RE: Erie Tropical_Vessel fallen down_27C01

Agitator Nozzle-Fatigue Calculation detail for AL agitators Only

Subject: 答复 : AD0598-RIIG-Calculation Review-26B34A/B & 26R03AB42A-Cone thickness

Forces and torques applied to the mounting flange at momentary locking of the propeller	
Torque M_v [Nm]:	1550
Bending torque M_b [Nm]:	13952
Side thrust F_s [N]:	1860
Thrust, propeller F_a [N]:	246
Critical speed [rpm]:	53

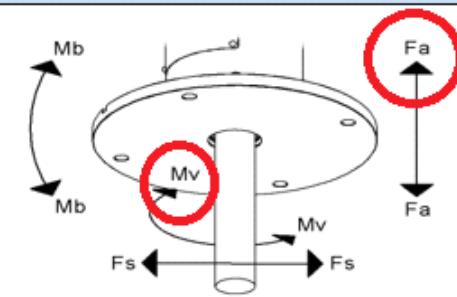
By looking at the Force and torque table from agitator spec attached, I can see that loads are given in two direction (+/-) for each line of the loads. For example, for M_b , the torque is 13952 Nm, and the schematic picture shows that this torque shall be expected either as 13952 Nm or -13952 Nm, same for other 3 loads. Considering the 4 loads given in below table, this will result in many different load cases (to be exact 64 different combinations). But, in order to qualify our nozzle for fatigue, we would need specific worst case for correct judgement.

So, my question is how we can reduce the number of variations in load cases and get the worst case scenario for loads based on the design criteria of agitator?

M_b and F_s could be in any direction.

Please be aware that the above loads is the worst case situation: Locking of the impeller and it includes safety factors due to the inertia from the rotating part in the motor.

- Option 1: as it is now (attached from RIIG)

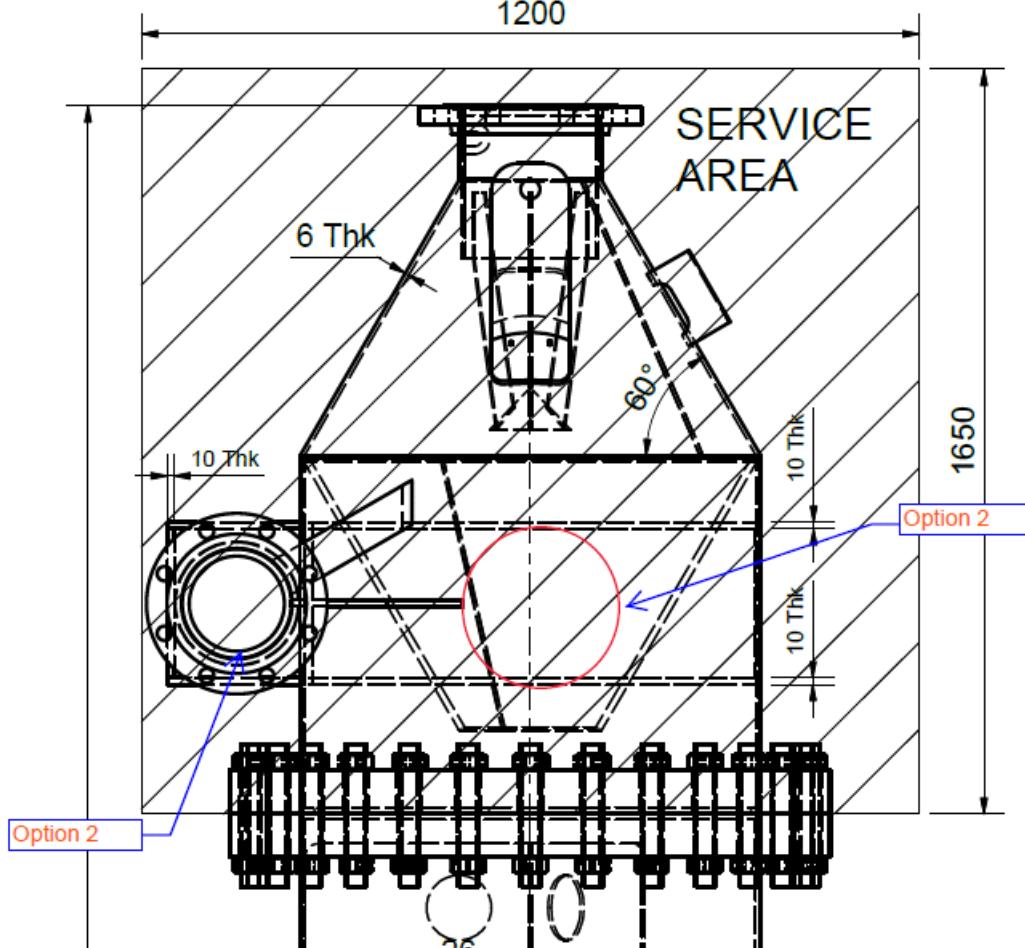
Please note that PID might show different location for oil and bleaching earth nozzles, but physical location of those nozzles wont be controlled by PID as normal.

Could you please help Ashvini to get drawing of the top part with the radial nozzle (option 2)? I suggest to keep thicknesses as it is, since the component is small. For the new nozzle, please use Sch. 40 rating as minimum and add a pad plate if possible.

主题: RE: AD0598-RIIG-Calculation Review-26B34A/B & 26R03AB42A-Cone thickness

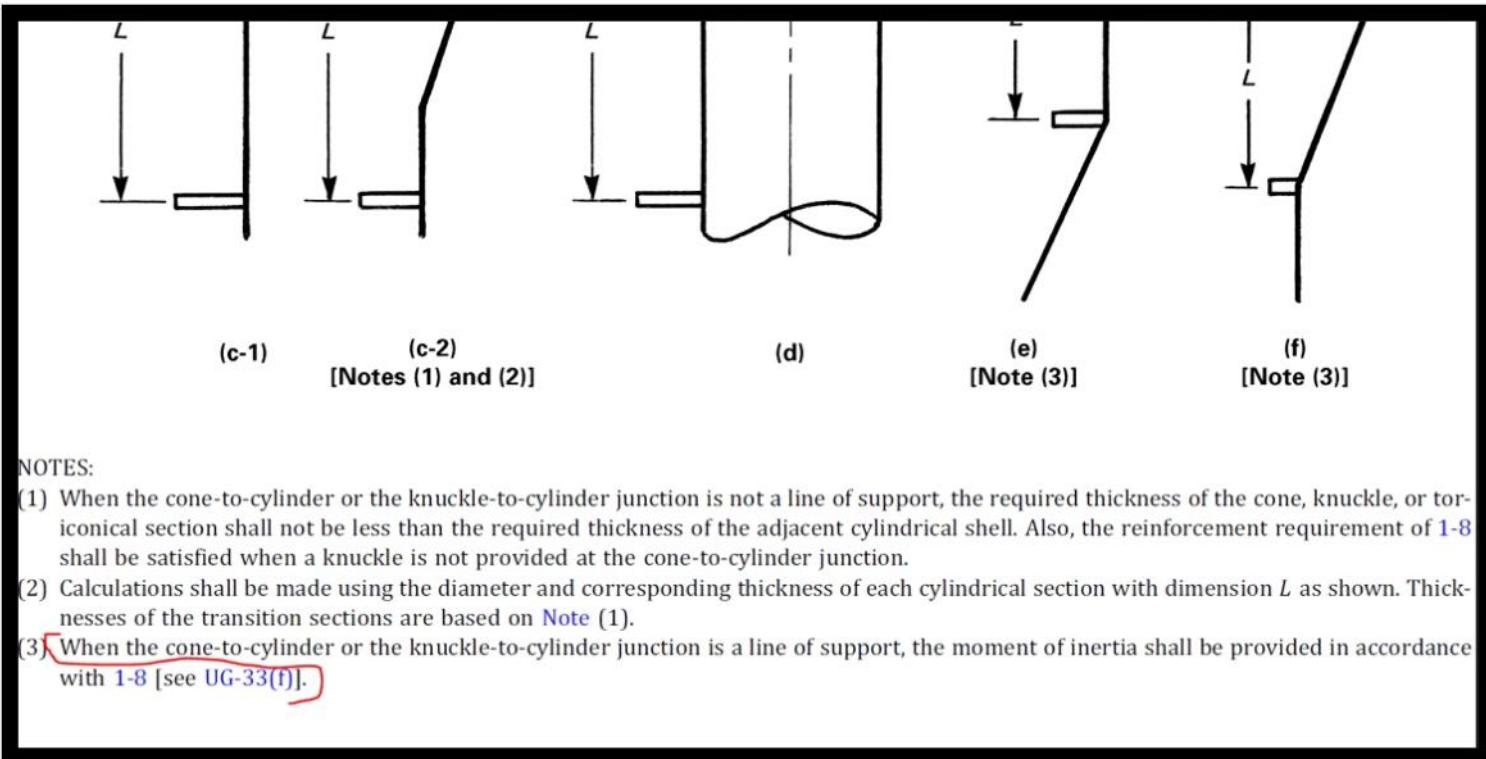
Code mentions in note 3 when cone to cylinder junction is line of support we need provide moment of inertia in accordance with 1-8(See UG-33 f)

As per our experience, the calculation length under external pressure will be decreased when we choose it as line of support so the thinner thickness of shell can be available. (inertia moment shall be considered and stiffener shall be added when calculation failed). But we can choose not a line of support if the shell thickness is enough.

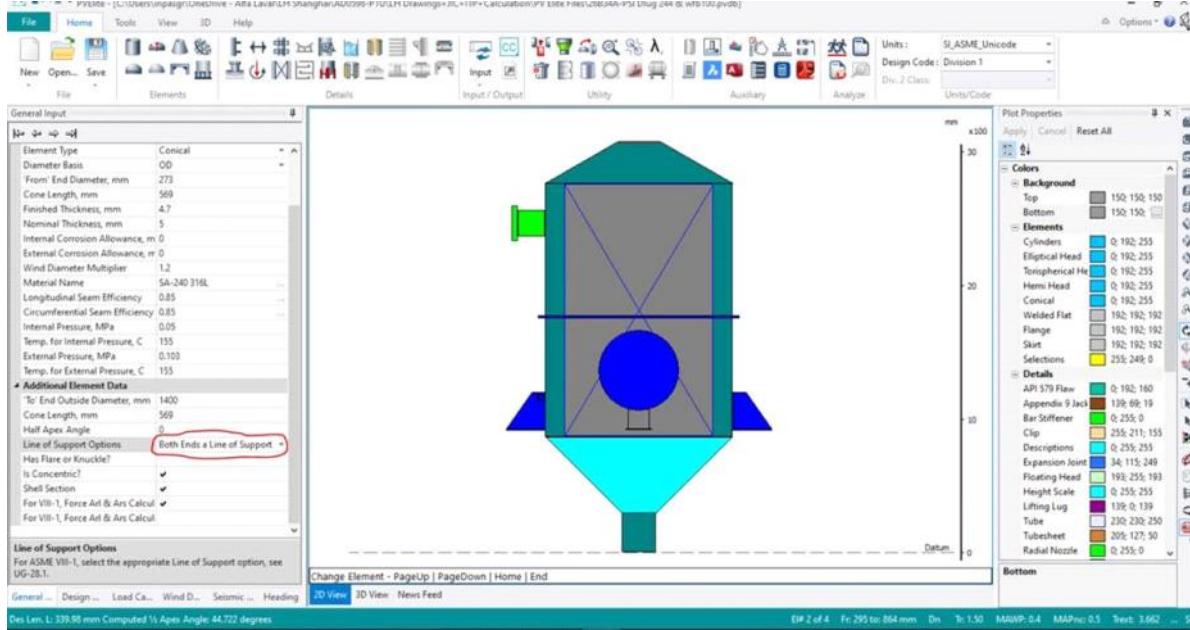
But we don't have stiffener at those position, so we need to use condition as "Not a line of support", and at this condition the bottom cone fails for 5mm thickness as per code.

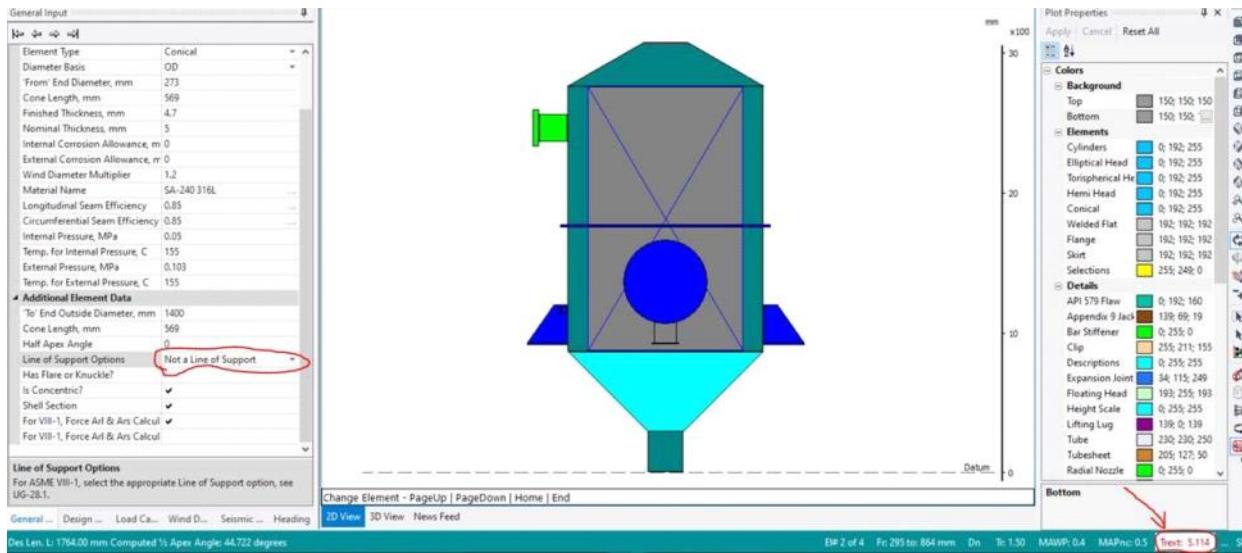
Same is the case for top cone also

Also for tanks 26R03AB42A and other similar cyclones, we have problem with top cone.

Please talk to your designer urgently and let us know his comments..

I think we need to add extra stiffeners in those vessels.

floating No guide in tank!

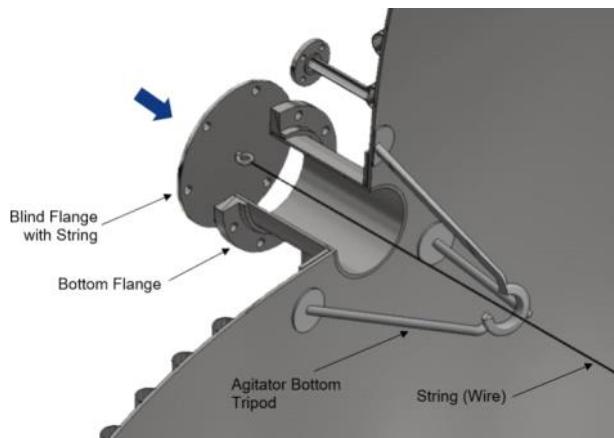
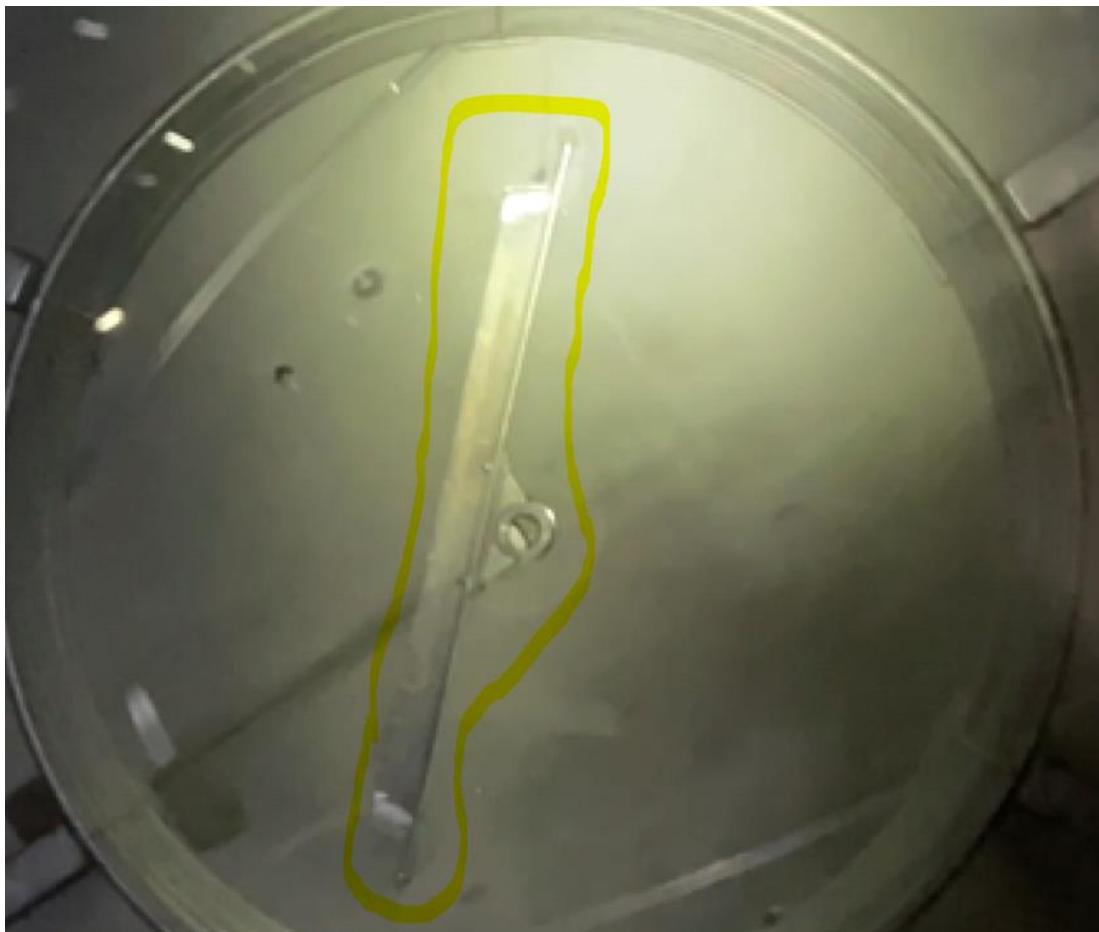
Acc. to drawings there is a "Agitator Bottom Tripod" that comes along with the tank or the mixer, that are to be centered & welded (what kind of weld & what dimension etc) to the tank bottom cone. While looking in inside T-2104 for M-2109 (Gums Collecting Tank) one can see a L-beam (?) with what looks like a bearing? Is that temporary and shall be replaced with the Tripod? Maybe it is a stupid question but I'm a bit confused here...or can we have a quick TEAMS on Monday after lunchtime?

Please explain/elaborate on this a bit, thanks.

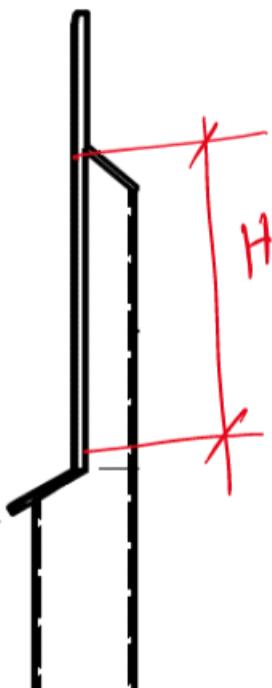
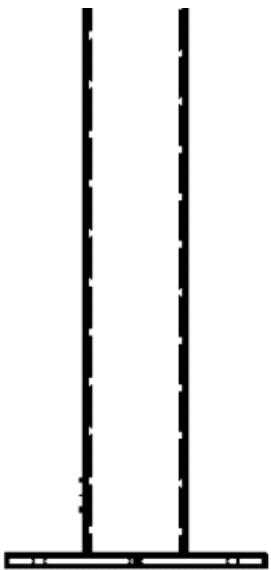
If you remember, I opened a dialogue to look at the leg design and see if we can avoid having a pad plate that goes over shell to head welding (and forms a cross weld).

Conclusion: based on the calculation approach in PV Elite and standards from different companies, there is no good reason change our existing standard.... So, our leg design would remain the same for tanks.

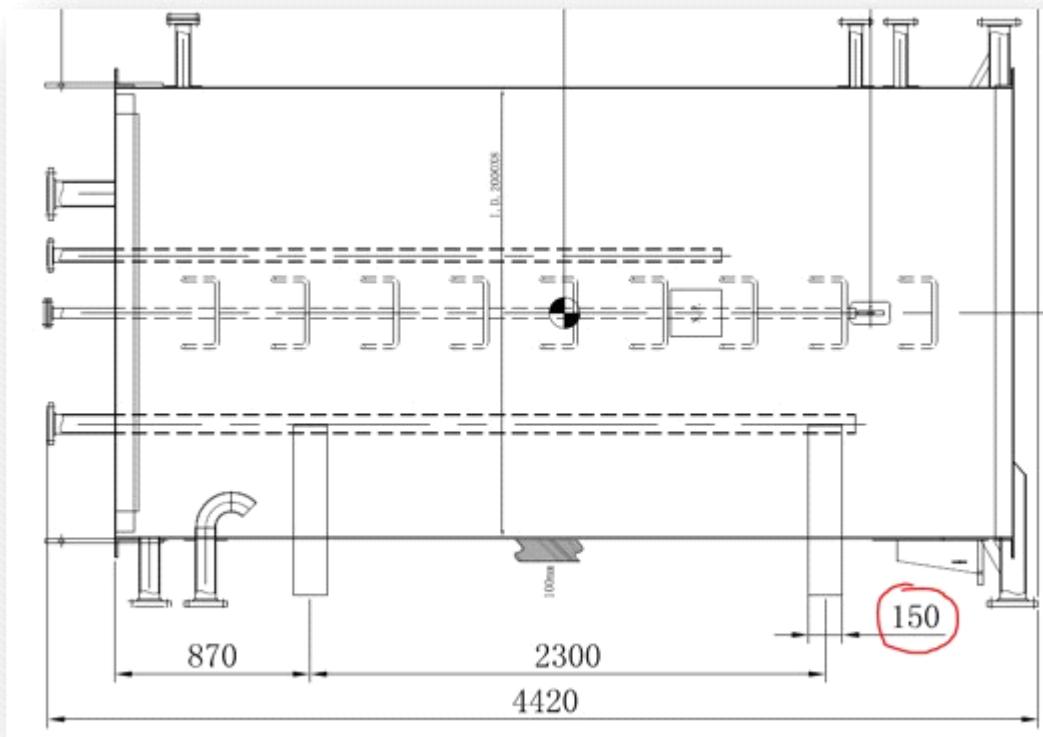
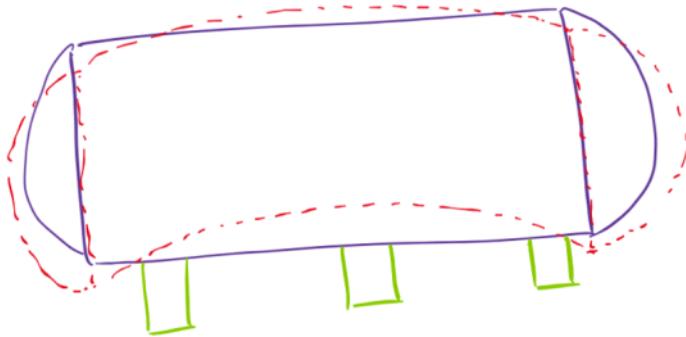
Please see below rule of thumb for dimension of support saddle width for transportation.

As mentioned below, this is only a guide, and it is not a requirement, but when receiving the shipping drawing from vendors, it could be used as a valuable reference.

Diameter	Weight	Saddle width
<1 m	<3 ton	100~150 mm
1~2 m	3~5 ton	150~200 mm
2~3 m	5~10 ton	250~300 mm
>3 m	>10 ton	300~350 mm

Please note that based on my research, we only shall use 2 saddle support for transportation, so, any number of saddle greater than 2 is not allowed. The reason is that if we use for example 3 saddle supports, there is a risk of deformation on shell with 3 lashing location on the truck bed (as an example shown below, if middle support is higher, there is a risk we will make a banana - delicious but not what we want 😊).

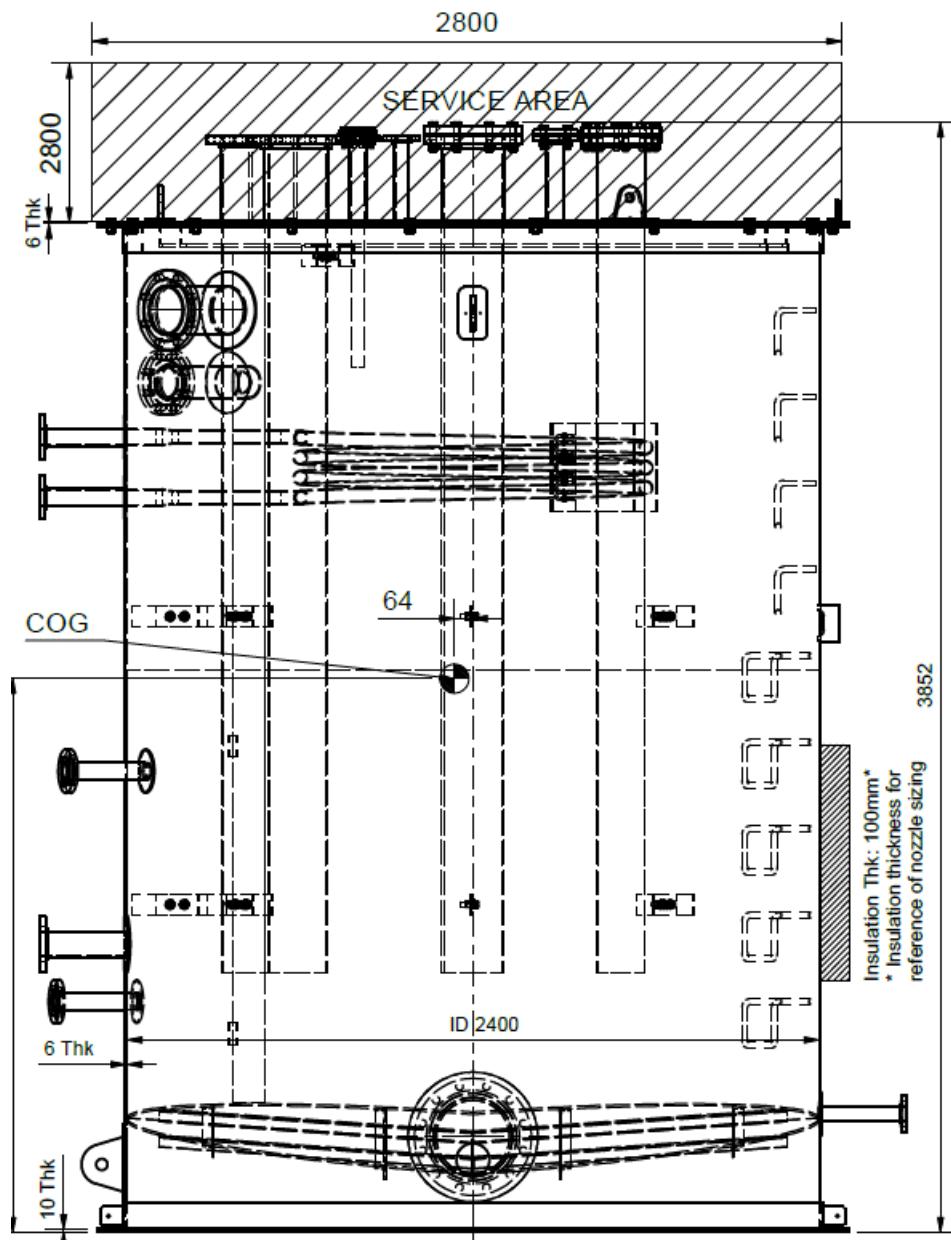
What if the coil is inside the tank (one example below) ? Shall it be treated with the same procedure that you described in attached or the tank would be exempted from CE marking?

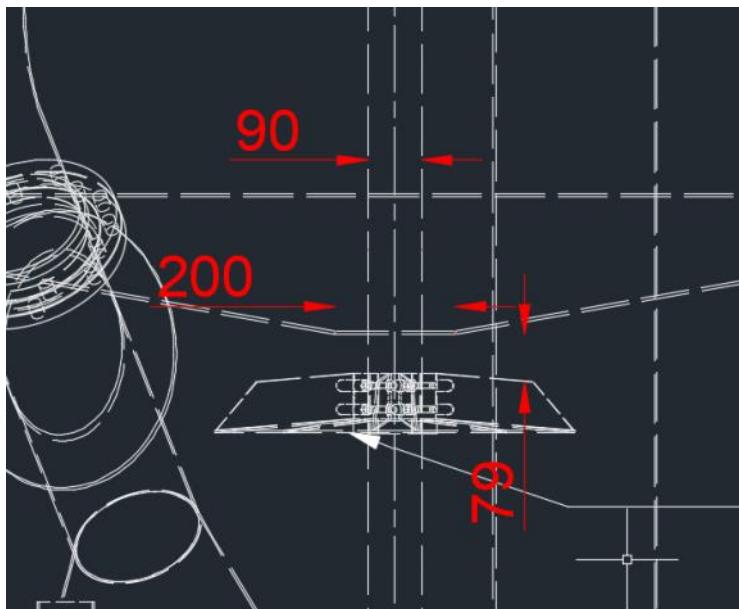
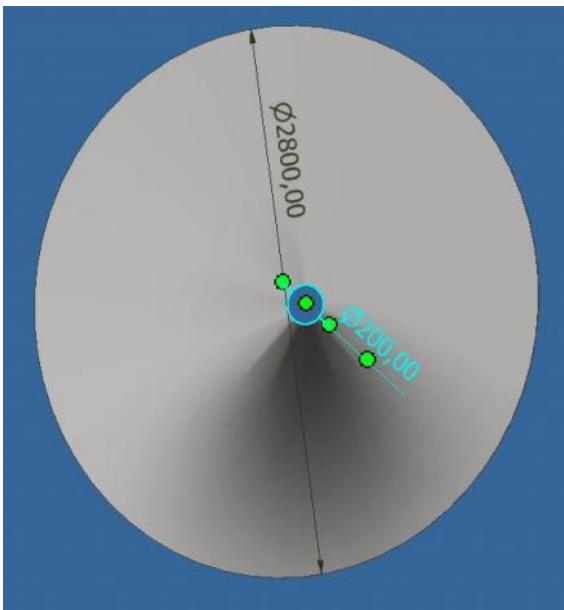
We have had an issued with a bleacher, where the center hole area of the tray and distance from the tray to Bolt-on Tray was not correct and we faced some issues during commissioning in ST1.

So, Alexey have developed an excel sheet based on Anatolii's original input and now this new excel sheet shall be used for all projects.

Please secure that this is done in all detail engineering project (not important for pre-engineering projects).

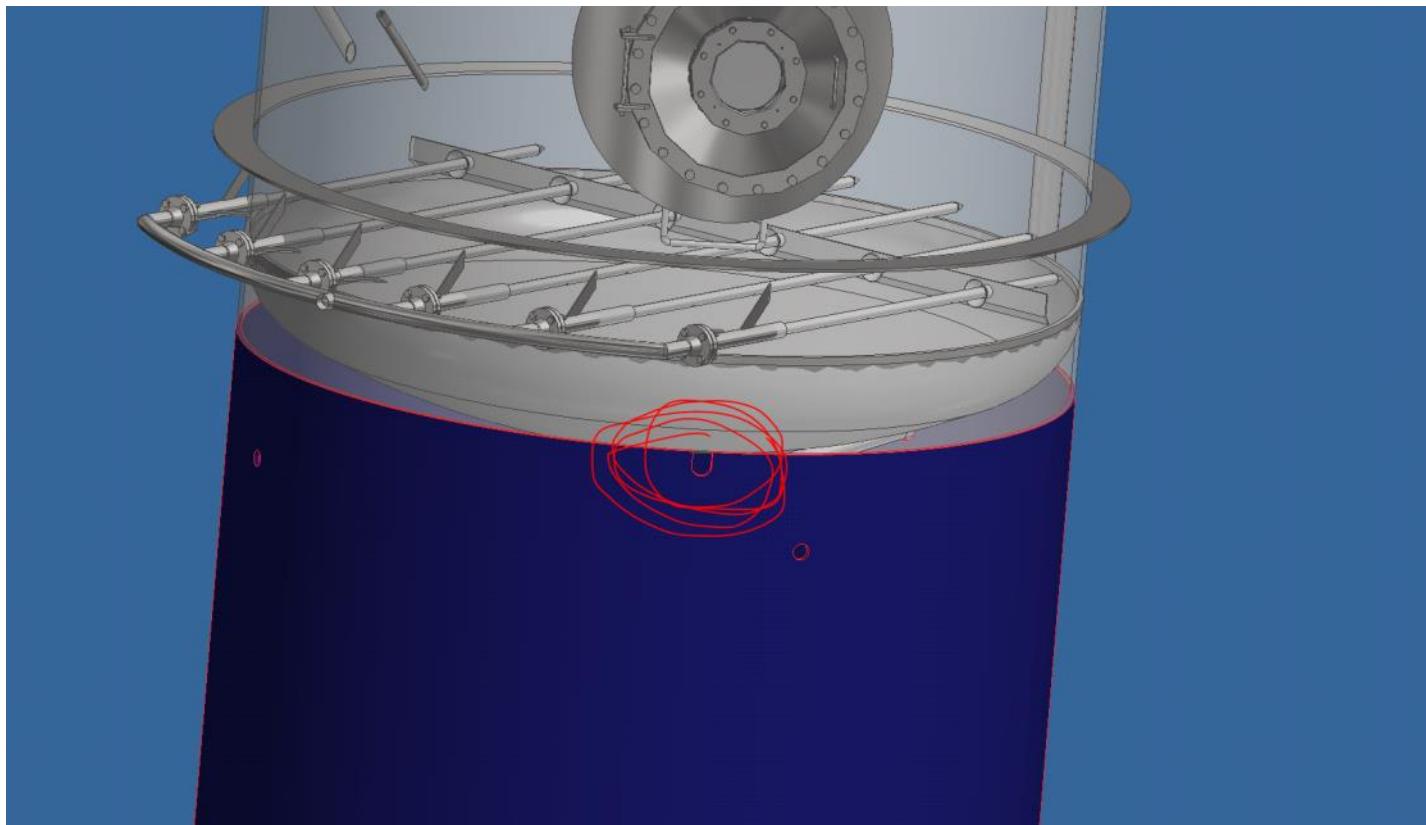
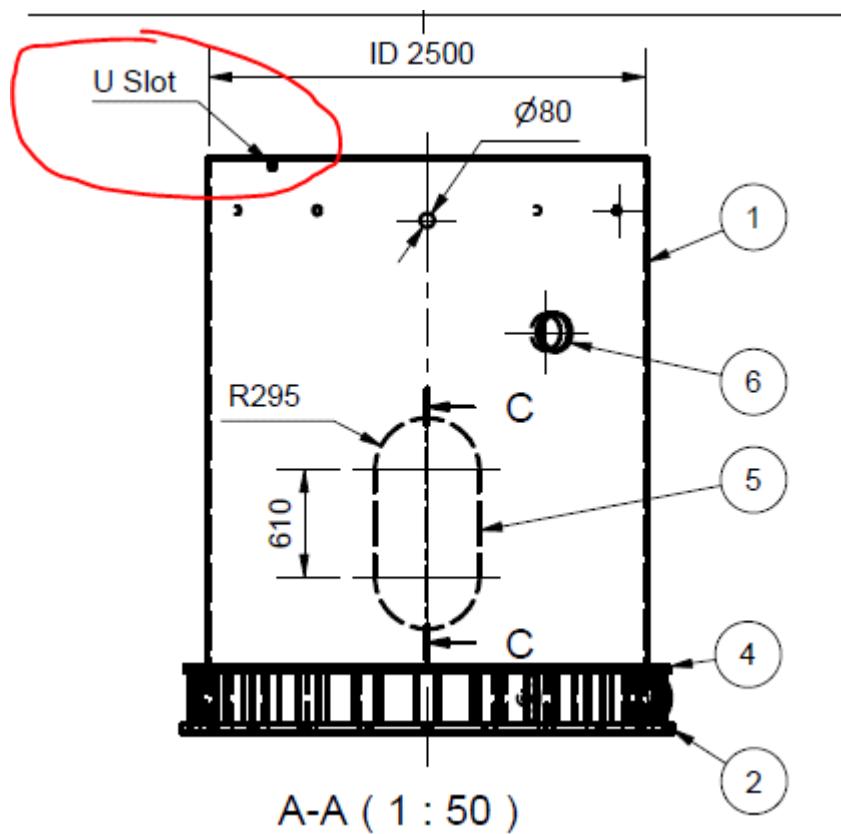
Do you know what the purpose of this u-slot?

That is for air escape-nothing major. Recommend to keep it as it is. Sometimes it can be used for hooking things and etc as well.
